Access Compliance Report Public Rights-of-Way (Curb Ramps)

Main Street: MESA_DR Cross Street: SANTA_ANA_AVE Location: N

ADA ID: RPAT220128173117 Ramp Type: Type 1 - Perpendicular Diagonal Initial Pass/Fail: Pass Overall Compliance: No Severity Score: 5

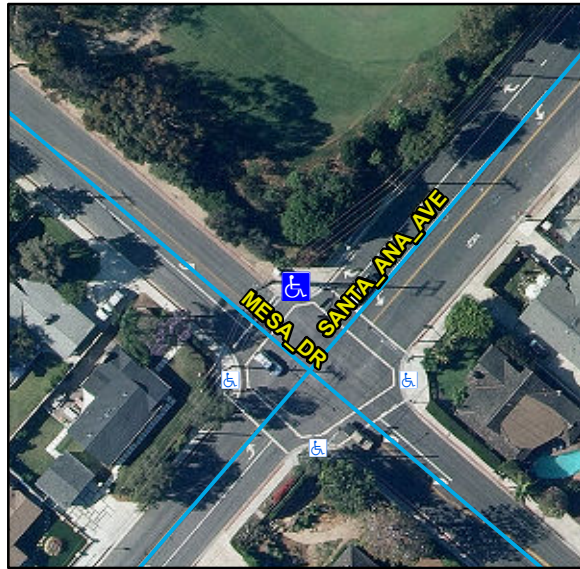
Compliance	Description	Data	Compliance	Description	Data
N/A	Ramp Length (in)	107	N/A	Flare Type LT	
Yes	Ramp Width (in)	49			Sloped
Yes	Ramp Run Slope (%)	6.7	N/A	Flare Slope LT (%)	6
Yes	Ramp Cross Slope (%)	0	N/A	Flare Traversable LT	No
N/A	Landing Present	Yes	N/A	Flare Type RT	
N/A	Landing Length (in)	64			Sloped
Yes	Landing Width (in)	49	Yes	Flare Slope RT (%)	7.8
Yes	Landing Run Slope (%)	1.5	N/A	Flare Traversable RT	Yes
Yes	Landing Cross Slope (%)	1	Yes	DWS Provided	Yes
N/A	Landing Movement Obstructed?	No	Yes	DWS Contrast	Yes
	Landing Movement Type	N/A	Yes	DWS Length (in)	36
N/A	Landing Shared	Yes	Yes	DWS Full Width	Yes
Yes	Clear Space	Yes	Yes	DWS Offset Left (in)	0
Yes	Clear Space To Crosswalk (in)	48	Yes	DWS Offset Right (in)	N/A
N/A	Marked Crosswalk 1	Yes	N/A	Marked Crosswalk 2	Yes
	Crossing 1 Direction	SW		Crossing 2 Direction	SE
	Marked Crosswalk 1 Width (in)	122		Marked Crosswalk 2 Width (in)	122

Yes	Ramp Inside Crosswalk 1	Yes	Yes	Ramp Inside Crosswalk 2	Yes
	Crossing 1 Slope (%)	4.3		Crossing 2 Slope (%)	3.5
	Crossing 1 Cross Slope (%)	1.3		Crossing 2 Cross Slope (%)	0.3
Yes	Gutter Ponding	No	No	Curb Slope	10
Yes	Gutter Lip Height (in)	0		Road Run Slope (%)	0.8
No	Gutter Run Slope (%)	7.1		Road Cross Slope (%)	4.2
Yes	Gutter Cross Slope (%)	0.7			
Yes	Overall Surface Condition: Acceptable		Yes	Perp Joint Present	Yes
	Cross Gutter Present?	No		Spandrel Present?	No
	Replace Cross Gutter?	N/A		Replace Spandrel?	N/A

Possible Solutions:

Remove & Replace Curb Slope. Remove & Replace Gutter. Utility Present.

R304.2.2, R304.5.4, STD 1115
